State of California  
AIR RESOURCES BOARD

**PROPOSED**

**CALIFORNIA EVAPORATIVE EMISSION STANDARDS AND TEST PROCEDURES  
FOR 2001 AND SUBSEQUENT MODEL MOTOR VEHICLES**

Second 15-Day Notice version, released 6/1/99  
Supplemental Comment Deadline: 6/15/99  
Board Hearing: 11/5/98

Figure 2: Test Procedure for 2001 and Subsequent Model Motor Vehicles

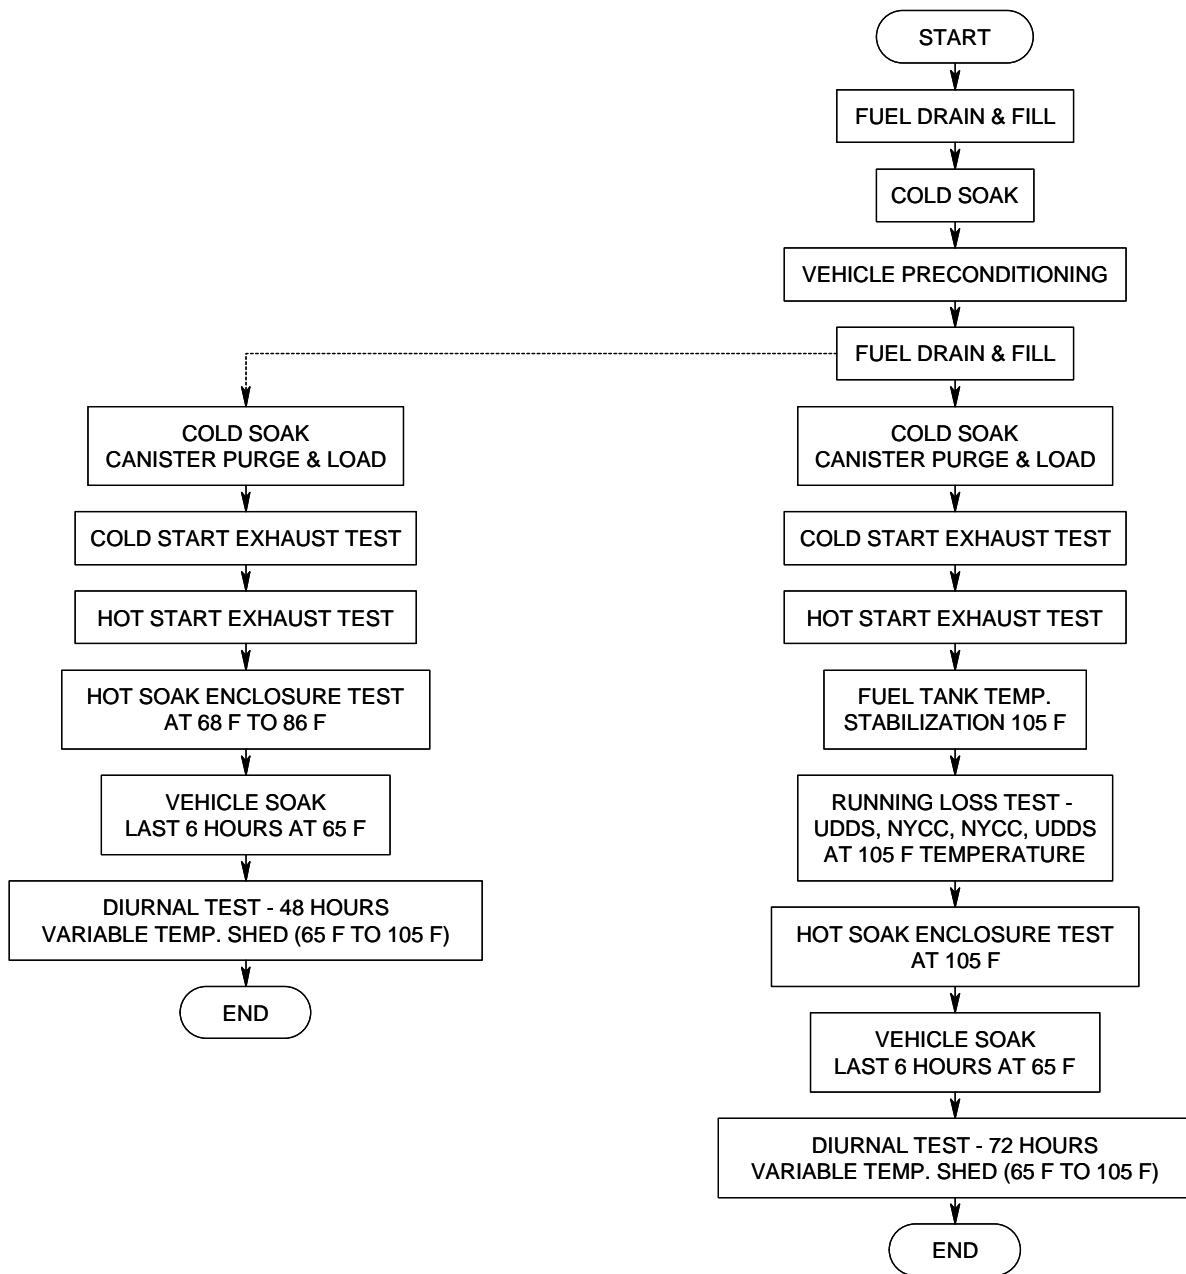
~~For 1993 to 1995 model hybrid electric vehicles and 1995 model motor vehicles, the test sequence shown in Figure 2 (Figure 3 for hybrid electric vehicles) describes the steps encountered as the vehicle undergoes the three-day diurnal sequence to determine conformity with the standards set forth. For 1996 and subsequent model motor vehicles, t~~ The test sequence shown in Figure 4 2 (Figure 5 3A or 3B for hybrid electric vehicles) describes the steps encountered as the vehicle undergoes the three-day diurnal sequence and the supplemental two-day diurnal sequence to determine conformity with the standards set forth. Methanol measurements may be omitted when methanol-fueled vehicles will not be tested in the evaporative enclosure. Ambient temperature levels encountered by the test vehicle throughout the entire duration of this test sequence shall not be less than 68°F nor more than 86°F, unless otherwise specified. The temperatures monitored during testing shall be representative of those experienced by the test vehicle. The test vehicle shall be approximately level during all phases of the test sequence to prevent abnormal fuel distribution. The temperature tolerance of a soak period may be waived for up to 10 minutes to allow purging of the enclosure or transporting the vehicle into the enclosure.

The three-day diurnal test sequence shown in Figure 2 (and Figure 3A or B for hybrid electric vehicles) is briefly described as follows:

The supplemental two-day diurnal sequence in Figure 4 2 (and Figure 5 3A or 3B for hybrid electric vehicles) shall be conducted according to the steps described in ~~(A)~~ 1.1 through ~~(D)~~ 1.4, ~~(F)~~, ~~(G)~~ 1.6, 1.7, followed by ~~(J)~~ 1.10 through ~~(L)~~ 1.12 of this paragraph except that the ambient temperature of the hot soak test is conducted at an ambient temperature between 68°F and 86°F at all times and that the diurnal test will consist of a two-day test. Emission sampling is

Figure 3A: Test Procedure for 2001 and Subsequent Model Hybrid Electric Vehicles

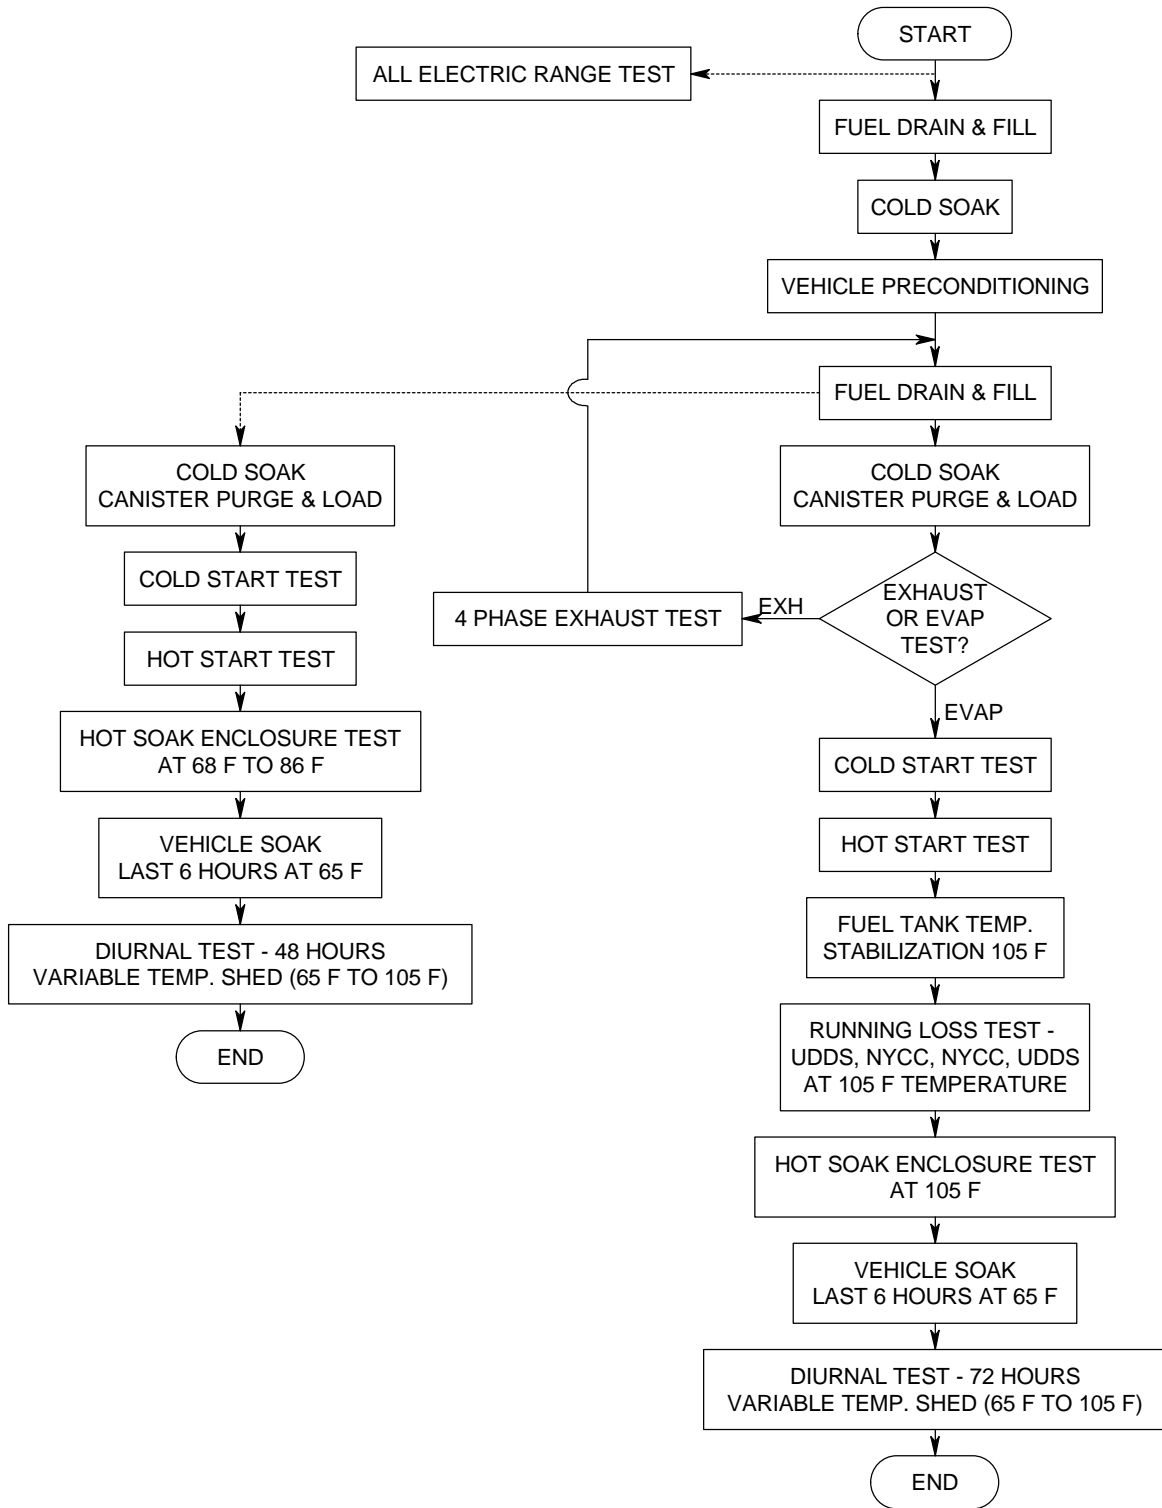
1.7.1 For hybrid electric vehicles, a four phase exhaust test shall be performed as shown in Figure 3A pursuant to the "California Exhaust Emission Standards and Test Procedures for 2003 and Subsequent Model Zero-Emission Vehicles, and 2001 and Subsequent Model Hybrid Electric Vehicles, in the Passenger Car, Light-Duty Truck, and Medium-Duty Vehicle Classes" as incorporated by reference in §1962(e), title 13, CCR. Following the four phase exhaust test, the test sequence shall repeat from step 1.3 of this section to conduct the evaporative test using the standard cold start test and hot start test (standard three phase test) without emission sampling. Battery state-of-charge setting prior to the standard three phase test shall be performed pursuant to section 6.1.6 of the "California Exhaust Emission Standards and Test Procedures for 2003 and Subsequent Model Zero-Emission Vehicles, and 2001 and Subsequent Model Hybrid Electric Vehicles, in the Passenger Car, Light-Duty Truck, and Medium-Duty Vehicle Classes" as incorporated by reference in §1962(e), title 13, CCR. Four phase exhaust testing may be performed in conjunction with evaporative testing as shown in Figure 3B with advance Executive Officer approval if the manufacturer is able to provide data demonstrating compliance with evaporative emission standards using the standard three phase test.

not required for the standard cold start test and hot start test (standard three phase test) in the supplemental two-day diurnal sequence as shown in Figure 3A.
